Access Compliance Report

Public Rights-of-Way

(Curb Ramps)

Intersection ID: N/A	Main Street: INDEPENDENCE_RD	Cross Street: N/A	Location: N
ADA ID: A4C6800B23FE	Ramp Type: PerpDiag	Initial Pass/Fail: Fail	Overall Compliance: No
Severity Score: 22.5			
Codes/Mitigation Info/Possible Solution		Field Measurements/Component Compliance

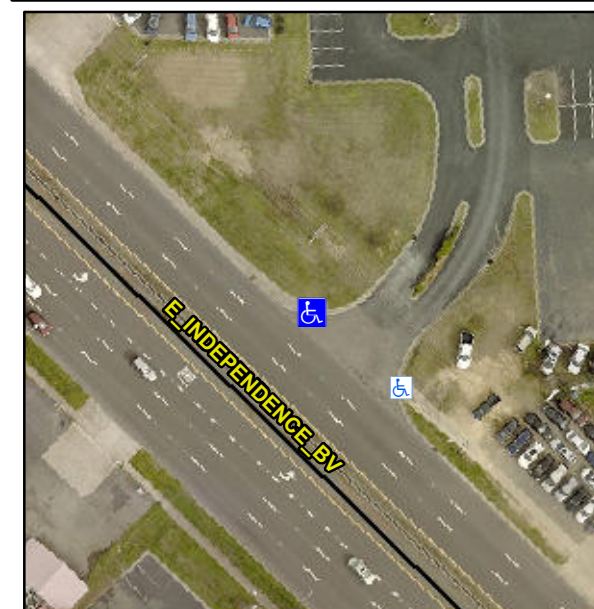
R304.5.1, R304.2.2

Compliance	Description	Data	Compliance	Description	Data
N/A	Ramp Length (in)	54.0	No	Ramp Slope (%)	9.6
No	Ramp Width (in)	41.0	Yes	Ramp XSlope (%)	2.5
N/A	Flare Type LT	N/A	N/A	Flare Type RT	N/A
N/A	Flare Slope LT (%)	N/A	N/A	Flare Slope RT (%)	N/A
N/A	Flare Traversable LT?	N/A	N/A	Flare Traversable RT?	N/A
N/A	Landing Length (in)	N/A	N/A	DWS Provided?	N/A
N/A	Landing Width (in)	N/A	N/A	DWS Contrast?	N/A
N/A	Landing Slope (%)	N/A	N/A	DWS Length (in)	N/A
N/A	Landing X Slope (%)	N/A	N/A	DWS Full Width?	N/A
N/A	Landing Curb? (Y/N)	N/A	N/A	DWS Offset (in)	N/A
N/A	Shared Landing?	N/A			
N/A	Gutter Ponding?	N/A	N/A	Gutter Slope (%)	N/A
N/A	Gutter Lip Ht (in)	N/A	N/A	Gutter X Slope (%)	N/A
N/A	Painted X Walk1?	No	N/A	Painted X Walk2?	No
	X Walk 1 Direction	To SW		X Walk 2 Direction	To SE
N/A	X Walk 1 Width (in)	N/A	N/A	X Walk 2 Width (in)	N/A
	X Walk 1 Slope (%)	5.6		X Walk 2 Slope (%)	4.2
	X Walk 1 X Slope (%)	3.3		X Walk 2 X Slope (%)	5.8

Remove & Replace Curb Ramp With Two New Directional Ramps or Equivalent.
